UNITED STATES PATENT AND TRADEMARK OFFICE

APPLICATION NO.	FILING DATE	FIRST NAMED INVENTOR	ATTORNEY DOCKET NO.	CONFIRMATION NO.
10/620,154	07/15/2003	David J. Talaber	R0372-00101	8486

Office Action Summary	Application No.	Applicant(s)	
	10/620,154	TALABER ET AL.	
	Examiner	Art Unit	
	Anu Ramana	3733

DETAILED ACTION

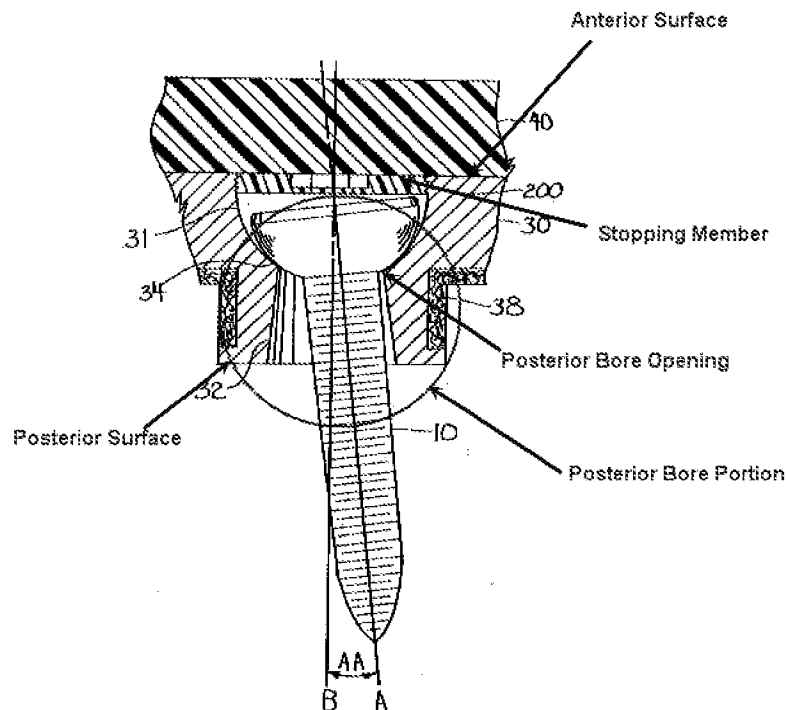
Claims 1-3, 9-11, 16-17 and 19 are rejected under 35 U.S.C. 102(b) as being anticipated by Dill (US 5,118,235).

Dill discloses a stabilizing element 10 having an anterior surface, a posterior surface and at least one bore 56 having a first opening in the anterior surface and a second opening in the posterior surface smaller than the first opening; a biased stopping member 80; a pin or "securing element" 14 having an elongated body 38 with a head 36 integral with the body, the head having a maximum diameter greater than the

smaller diameter configuration of the passageway; and a curved lip or "biased stopping member" 80 that defines a reversibly expandable passageway (Figs. 2 and 7, col. 3, lines 33-68 and col. 4, lines 1-16).

Please refer marked up Fig. 7 from Hodorek below.

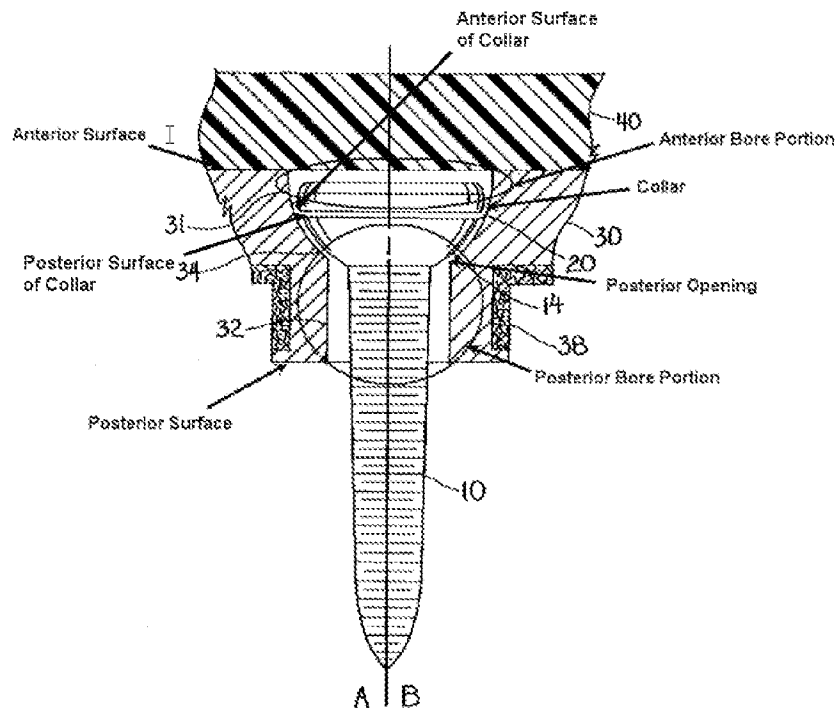
Using an alternate interpretation, claims 29-31, 33-37, 39-40, 42-48, 60, 89-95, 102, 105 and 114 are rejected under 35 U.S.C. 102(b) as being anticipated by Hodorek (US 5,534,032).

Hodorek discloses an orthopedic implant assembly including: a stabilizing element 30 having an anterior surface, a posterior surface and at least one bore extending through the stabilizing element from the anterior surface to the posterior surface; a posterior bore portion having a posterior opening with a transverse dimension smaller than a transverse dimension of the anterior bore portion; a securing element 10 having an enlarged integral portion 11; a radially deflectable or longitudinally deflectable member 20 including a raised portion or collar (Fig. 6 and col. 3, lines 6-40). Please refer marked up Fig. 6 on the following page. Note that member 20 is resilient and is therefore capable of being radially as well as longitudinally deflectable.

Regarding claim 105, it is noted that member 20 is capable of returning to the first configuration after passage of the enlarged integral portion of the securing member. It is noted that Applicant's are not claiming that the securing member has to pass through the biased stopping member in order for orthopedic implant to be assembled.

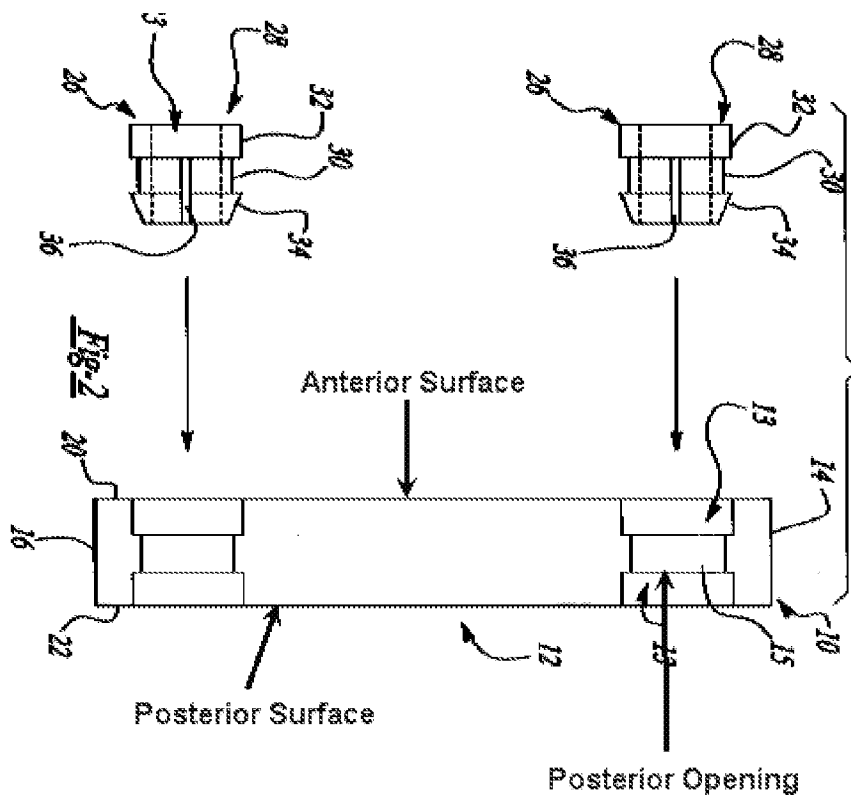
Claims 29, 31, 36, 42-48, 50 and 89-105 are rejected under 35 U.S.C. 102(e) as being anticipated by Richelsoph (US 6,017,345).

Richelsoph discloses an orthopedic implant assembly including: a plate or "stabilizing element" 12 having an anterior surface and a posterior surface; a bore extending from the anterior surface to the posterior surface, the bore having an anterior bore portion and a posterior bore portion with a posterior opening with a transverse dimension smaller than a transverse dimension of the anterior bore portion (the stepped

bore presents an opening or aperture at each step); an insert or "stopping member" or "resilient member" 28 having a biased collar disposed within the bore, the insert defining a reversible expandable passageway wherein a second transverse or expanded configuration is larger than a transverse dimension of a first or unexpanded or normal biased configuration; and a screw or "securing element" 40 having an enlarged portion 54 is slidably disposed in the bore of the stabilizing element (Figs. 2-17, col. 4, lines 32-67 and col. 5, lines 1-67). See marked up Fig. 2 from Richelsoph below.

Regarding claim 89, enlarged integral portion has a maximum transverse dimension defined by head 50, greater than a transverse dimension of the posterior opening of the posterior bore portion.

Regarding claims 94 and 96, insert 28 is longitudinally or radially deflectable upon application of a suitable force by virtue of being compressible.

Regarding claim 105, it is noted that insert 28 is capable of returning to the first configuration after passage of the enlarged integral portion of the securing member. It is noted that Applicant's are not claiming that the securing member has to pass through the biased stopping member in order for orthopedic implant to be assembled.

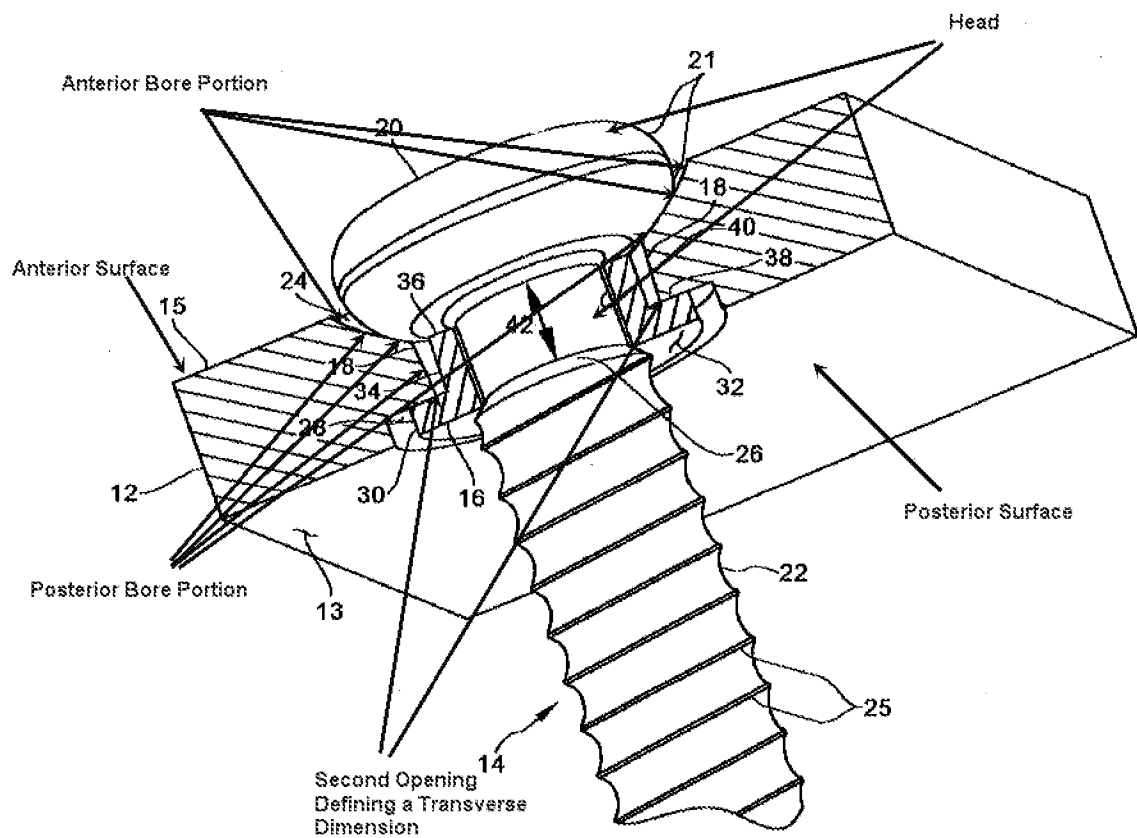
Claims 1, 10-17, 29, 31, 33, 36, 42-50, 52-53, 60, 63-79, 89-96, 99-103, 106 and 114 are rejected under 35 U.S.C. 102(b) as being anticipated by Estes (US 5,578,034).

Estes discloses an attachment component or stabilizing element 12 including: an elongated securing member 14 having a head with a maximum diameter defined by the enlarged head portion 20 and a smaller diameter portion connecting the enlarged head portion 20 to screw shaft 22; a bore 18, the bore having an anterior bore portion and a posterior bore portion, the posterior bore portion having at least one transverse dimension smaller than the transverse dimension of the enlarged integral portion of the securing member; a stopping member 16 which reduces a transverse configuration of the bore, to define at least in part the posterior bore portion to retain the enlarged integral portion of the securing member wherein the collar is formed of an elastically deformable or superelastic material (Fig. 1, col. 4, lines 36-67, col. 5 and col. 6, lines 1-46). See marked up Fig. 1 from Estes on the following page.

Regarding claims 69 and 70, the Examiner notes that the limitation "configured to expand the collar.....the collar passageway" and "configured to contact an anterior surface of the collar and deflect the collar away from a longitudinal axis of the collar passageway" is met by Estes, because the enlarged integral portion of the securing

Applicant's arguments with respect to the rejections of claims 60, 63-67, 73 and 89-95 as being anticipated by Estes (US 5,578,034) are not persuasive for the following reason. The bore of Estes has an anterior bore portion and a posterior bore portion as illustrated in marked up Fig. 1 from Estes on page. It is noted that the Examiner is interpreting the "anterior bore portion" to be a small portion of the bore close to the anterior surface of the plate with the rest of the bore defining the posterior bore portion. Further, the head of the securing member has two portions, an enlarged portion and a smooth portion connecting the enlarged portion to the screw shaft. Contrary to Applicant's arguments, Estes discloses Applicant's claimed invention as discussed in the rejections above and therefore anticipates the claims.
